Vermont Agency of Transportation
RECEIVED
 CK'D BY RK/JW OK'D BY RY
 February 12, 2015
 RESUBMIT No Approved
 BY RY DATE 02/12/2015

APPROVAL STAMP:	J.P. CARRARA & SONS INC. Precast & Prestress Manufacturer 244 GAGE ST., MIDDLEBURY, VERMONT 05753 Phone: (802)388-6361 Fax: (802)388-9010		A.L. St. ONGE CONTRACTOR MONTGOMERY, VERMONT	
	STATE OF VERMONT AGENCY OF TRANSPORTATION COUNTY OF FRANKLIN		DATE: NOV. 10, 2014	SCALE: NOTED
	TOWN OF FAIRFIELD SOUTH ROAD, FAS 0281 (RURAL MAJOR COLLECTOR) BRIDGE NO.: 14 PROJECT NO.: BRP 0281(25)		CHKD: B.C. DFTM: B.L.	JOB NO: 23446-014
	PRESTRESSED SOLID SLAB & PRECAST APPROACH SLAB LAYOUT		DWG. NO:	F2

TOWN OF FAIRFIELD
SOUTH ROAD, FAS 0281 (RURAL MAJOR COLLECTOR)
BRIDGE NO.: 14 PROJECT NO.: BRF 0281(25)

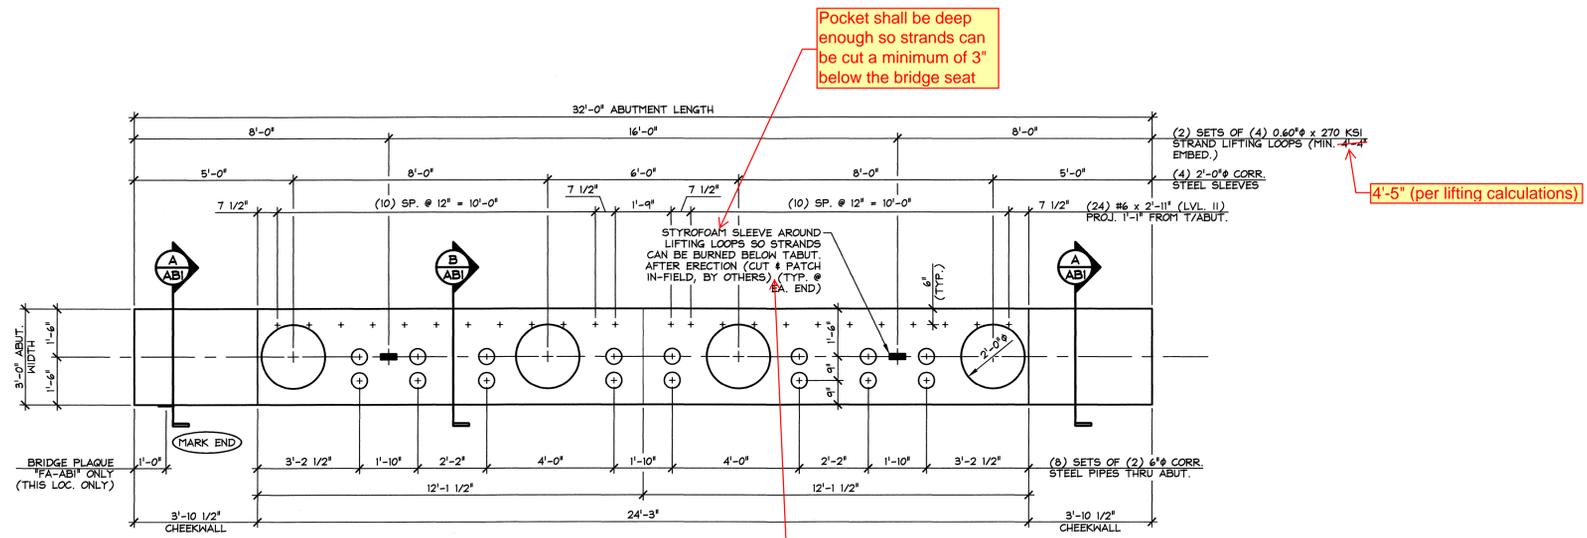
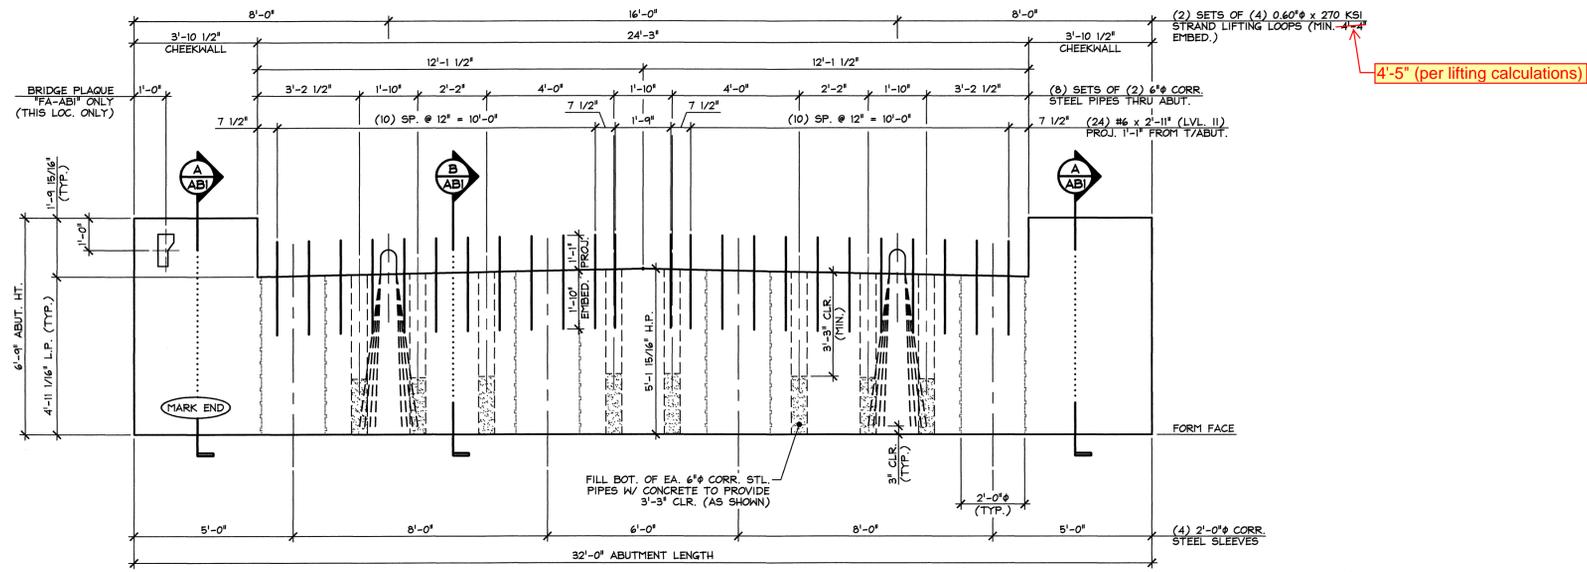
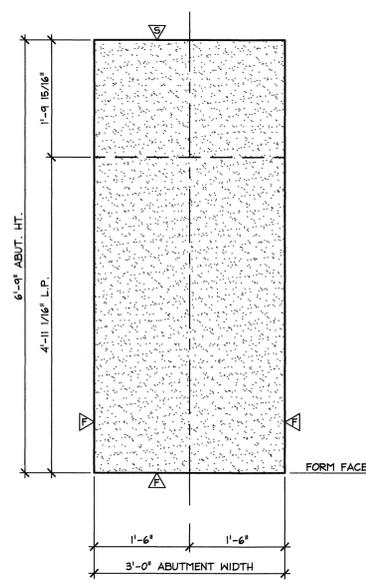
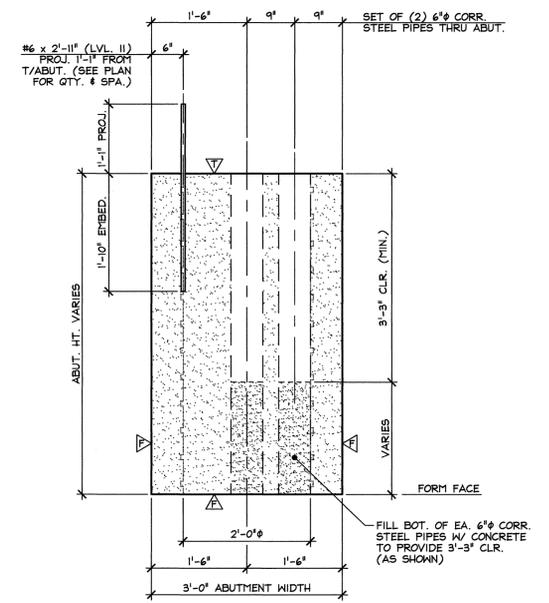
Pocket shall be deep enough so strands can be cut a minimum of 3" below the bridge seat

After strands are cut 3" below the bridge seat, clean all debris from pocket including any loose concrete before filling pocket with Mortar, Type IV

PRECAST APPROACH SLABS

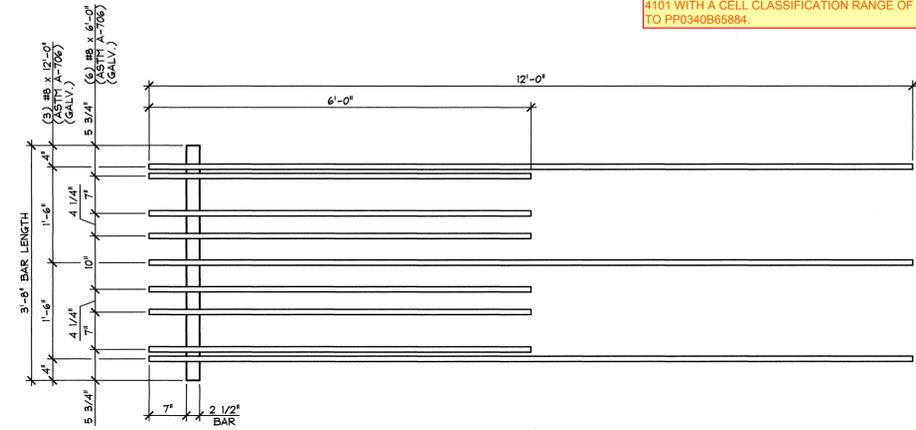
Material requirements per note 20, sheet 8/69 of contract plans:
CORRUGATED POST-TENSIONING DUCTS IN THE PRESTRESSED SLABS AND PRECAST APPROACH SLABS FOR ANCHOR BOLT AND DOWEL CONNECTIONS SHALL BE CONSTRUCTED FROM EITHER POLYETHYLENE OR POLYPROPYLENE. THE DUCT SHALL HAVE A MINIMUM MATERIAL THICKNESS OF 0.080 IN. +/- 0.010 IN. AND SHALL HAVE A WHITE COATING ON THE OUTSIDE OR SHALL BE OF WHITE MATERIAL WITH ULTRAVIOLET STABILIZERS ADDED. POLYETHYLENE DUCT SHALL BE FABRICATED FROM RESINS MEETING OR EXCEEDING THE REQUIREMENTS OF ASTM D 3350 WITH A CELL CLASSIFICATION OF 345464A. POLYPROPYLENE DUCT SHALL BE FABRICATED FROM RESINS MEETING OR EXCEEDING THE REQUIREMENTS OF ASTM D 4101 WITH A CELL CLASSIFICATION RANGE OF PP0340B44544 TO PP0340B65884.
